Service Report (3)

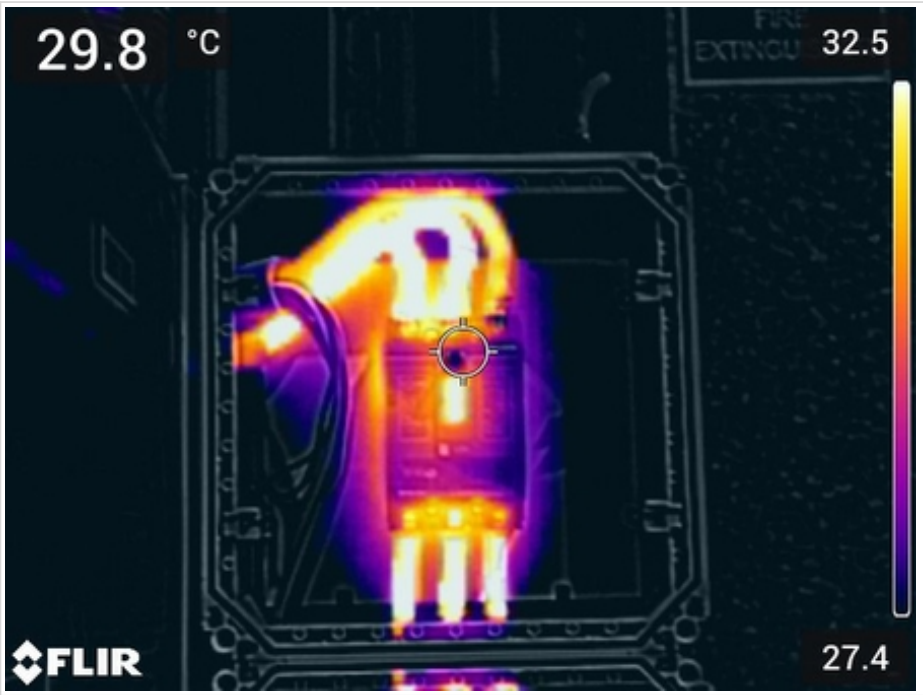
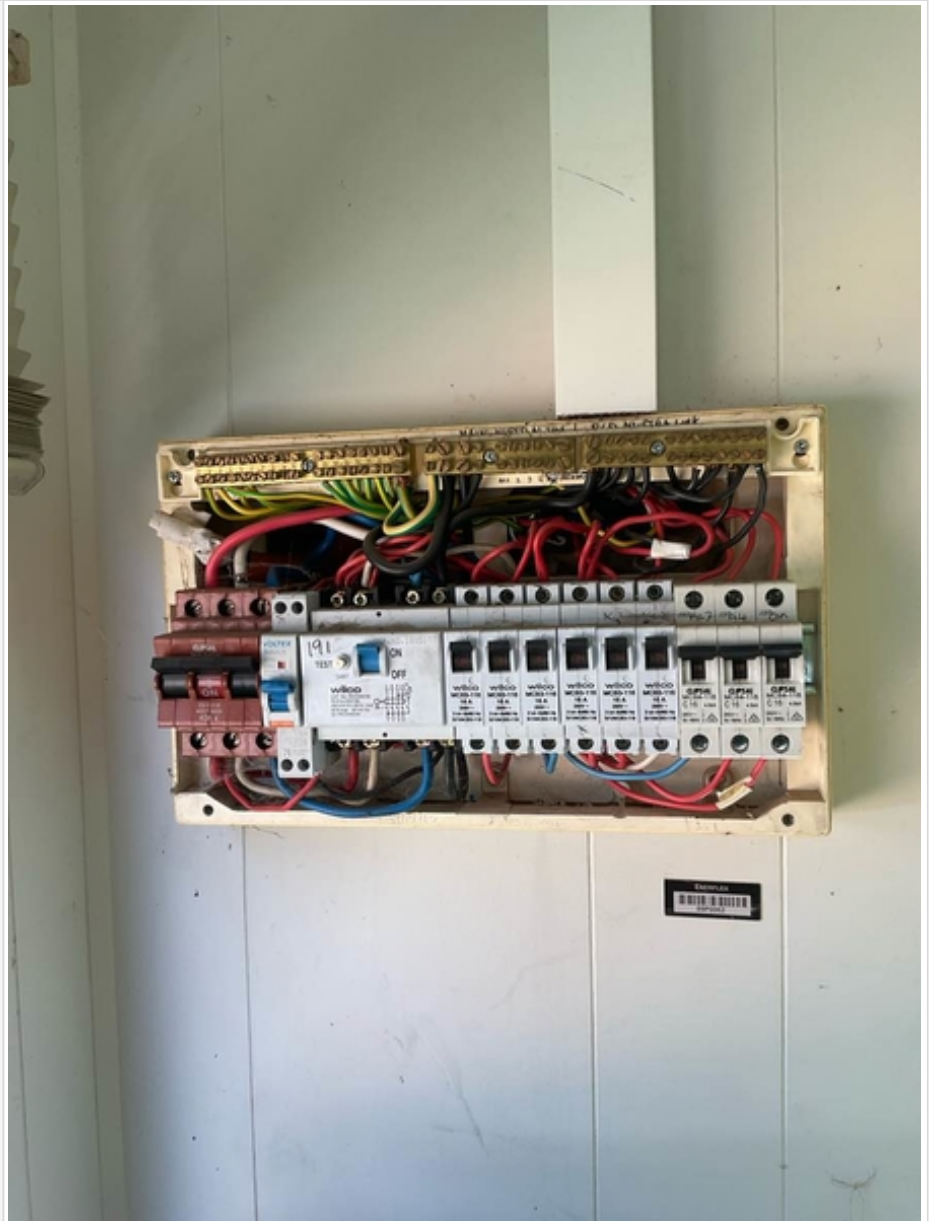
Switchboard Inspection Status	Pass
Comments and Recommendations	Exposed copper termination in cooler circuit breaker. Suggest retermination Appears to be unbalanced load on red and white phase
Next inspection Due	Feb 2026

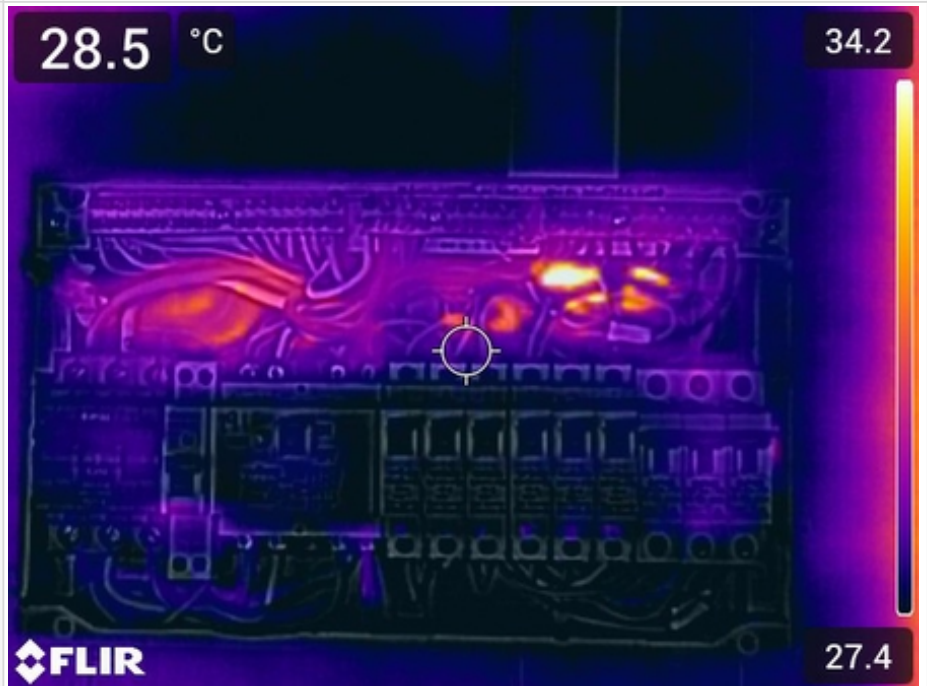
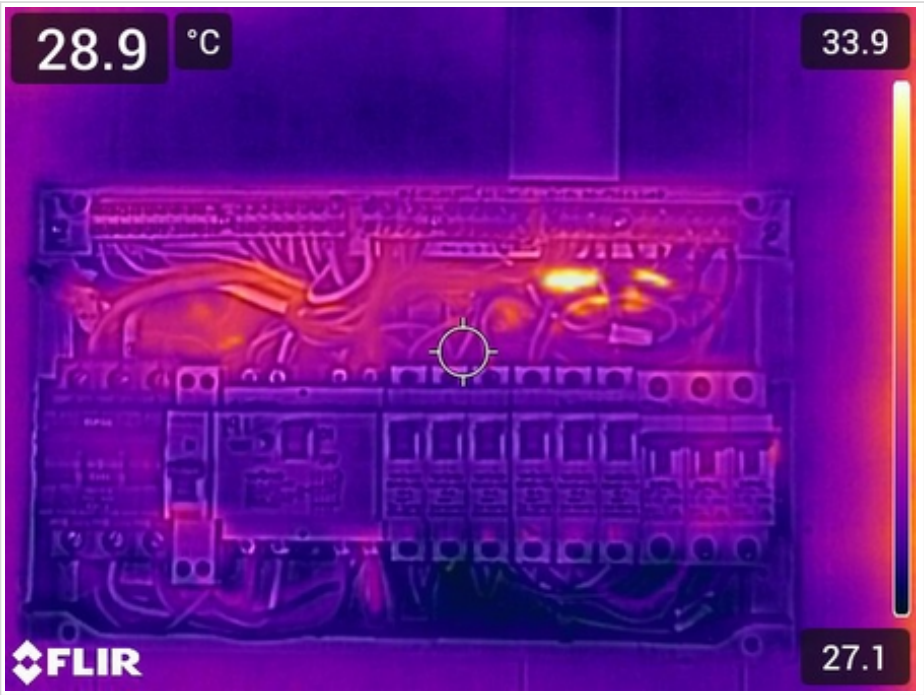
Switchboard Inspection Status	Pass
Comments and Recommendations	SWB labels remarked
Next inspection Due	Feb 2026
